Description and justification of change in FE-LO interface

This memo summarises a proposed change in the original FE-LO interface boundary as described in the ALMA projectbook version 4.0 of 2001-02-08.

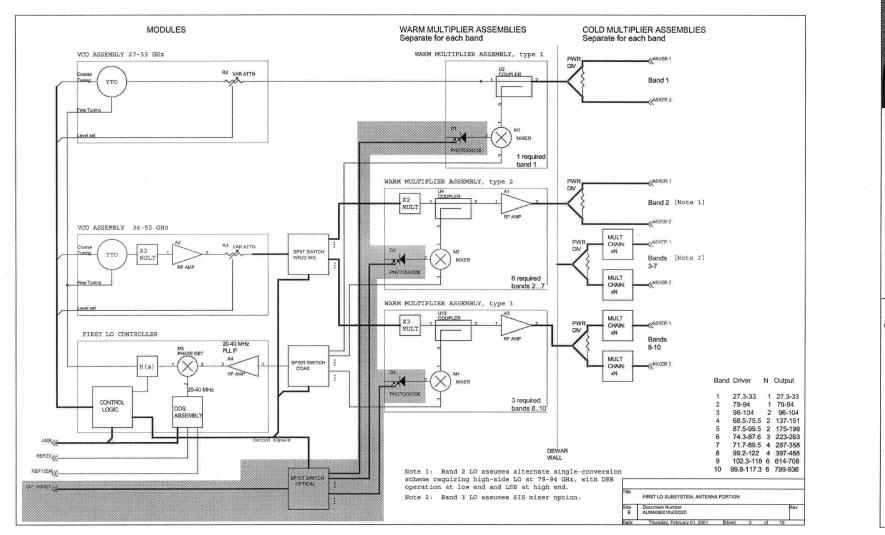
The First Local Oscillator sub-system becomes an integral part of the Front End assembly. The FE-LO interface is then:

- 1. The input at the First LO Controller of the 125 MHz reference signal (REF125M) coming from the Reference Receiver.
- 2. The input at the First LO Controller of the 20.83333 Hz reference signal (REF20) coming from the Reference Receiver.
- 3. The waveguide input at each Warm Multiplier Assembly for a microwave reference signal generated by the Dual-Laser Photodiode Assembly. For each frequency band there is a separate Warm Multiplier Assembly, resulting in 10 different interfaces.
- 4. Mechanical interfaces for the Dual-Laser Photodiode Assembly mounted on all 10 Warm Multiplier Assemblies.
- 5. A mechanical interface between the Reference Receiver and the Front End rack.
- 6. A mechanical interface between SP10T Optical Switch and Front End Rack
- 7. Electronic control of SP10T optical switch from First LO Controller

The block diagram attached at the end of this memo gives a graphical representation of this new FE-LO interface boundary. The whole First LO sub-system as depicted in this block diagram comes under the responsibility of the Front End IPT with the exception of the shaded area which remains under the responsibility of the Back End IPT.
